BRAKE HOSE INSPECTION Prevost vehicles

DESCRIPTION

On the vehicles affected by this bulletin the brake hose may come in contact with the air spring support when vehicle is in low or high buoy position. Perform an inspection. Depending on the result, adjust the hoses to avoid any interference.

Figure 1

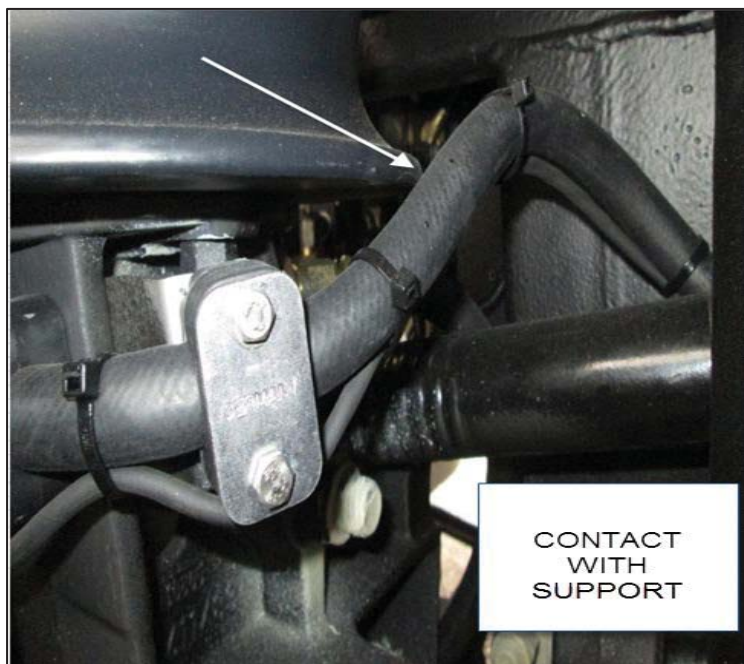
1. On each side of the vehicle, make sure that the brake hose to the brake booster does not come into contact when suspension is in low or high buoy.
2. If no contact is found, end the bulletin here.

Figure 2

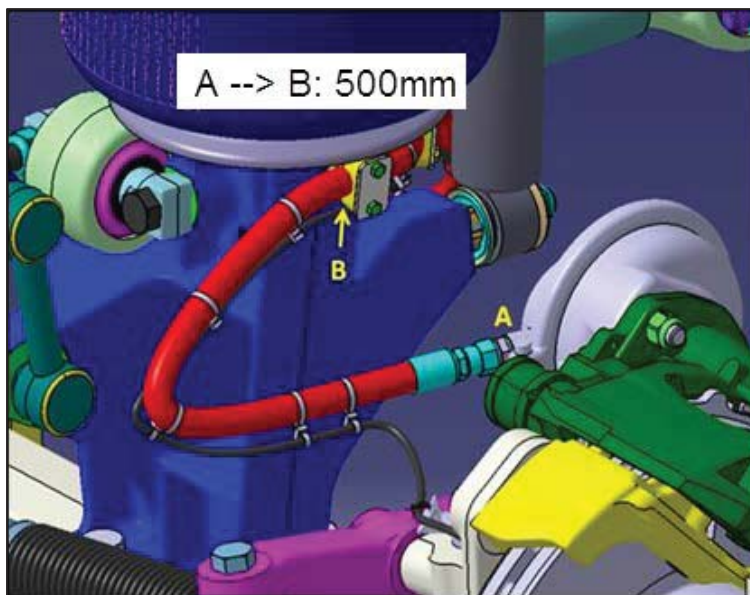
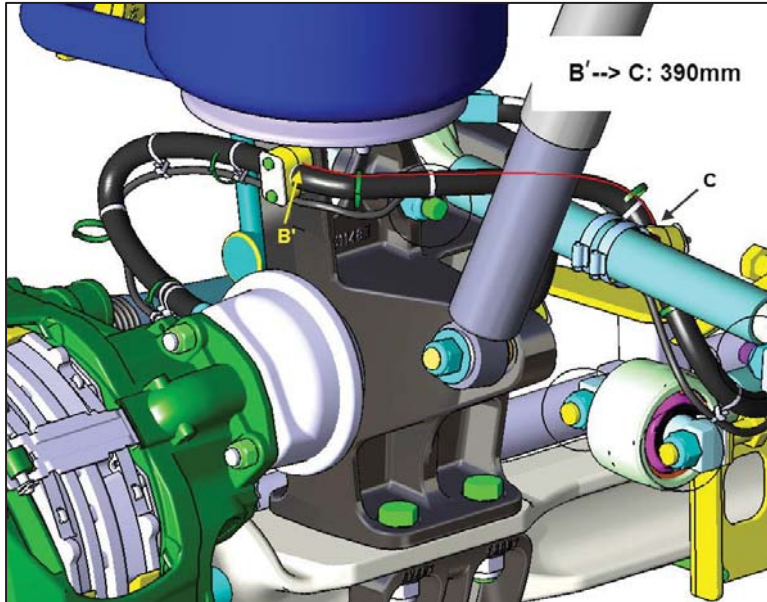
3. If there is interference, reposition the hose on each side of the vehicle as shown in fig. 2 and 3.

4. Measure and mark distances below on hose and adjust hoses as required to avoid interference.
 - From A to B: 500mm (19 5/8")
 - From B' to C: 390mm (15 3/8")
